Design Review Board

Meeting Minutes

**Mesa City Council Chambers - Lower Level, 57 East 1st Street
Date: October 14, 2025 Time: 4:30 p.m.**

- 3b DRB25-00686 "Redhawk - Phase 3"** 187± acres located at the northwest corner of South Sossaman Road and East Elliot Road. Design Review of a Data Center. **(District 6)**

Landscape Plan

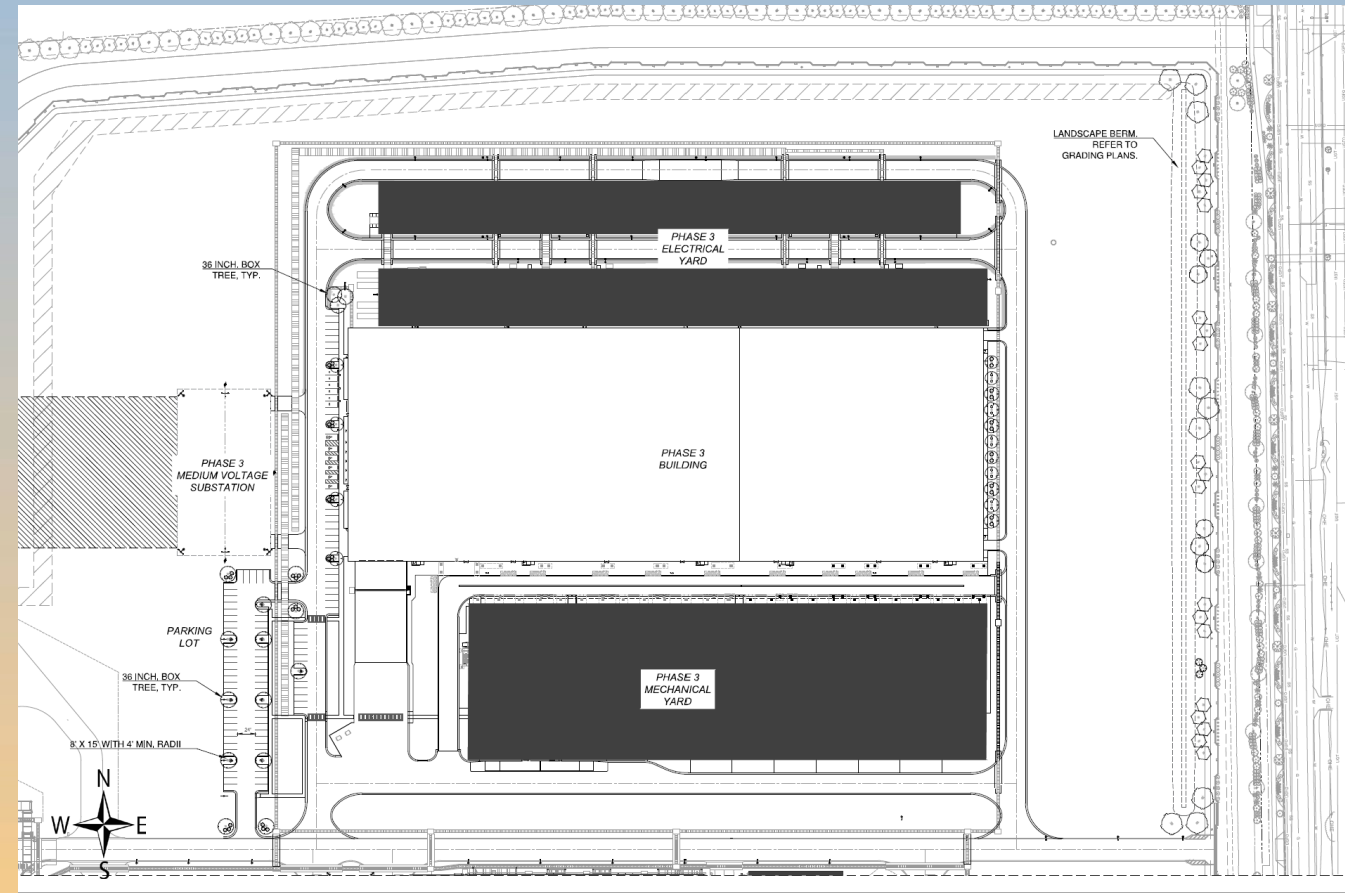
- Replace the Chrysactinia Mexicana "Damianita" shrubs with a hardier shrub better suited for the Arizona environment.
- Add trees and shrubs to the median area located to the south of the Phase 3 mechanical yard.
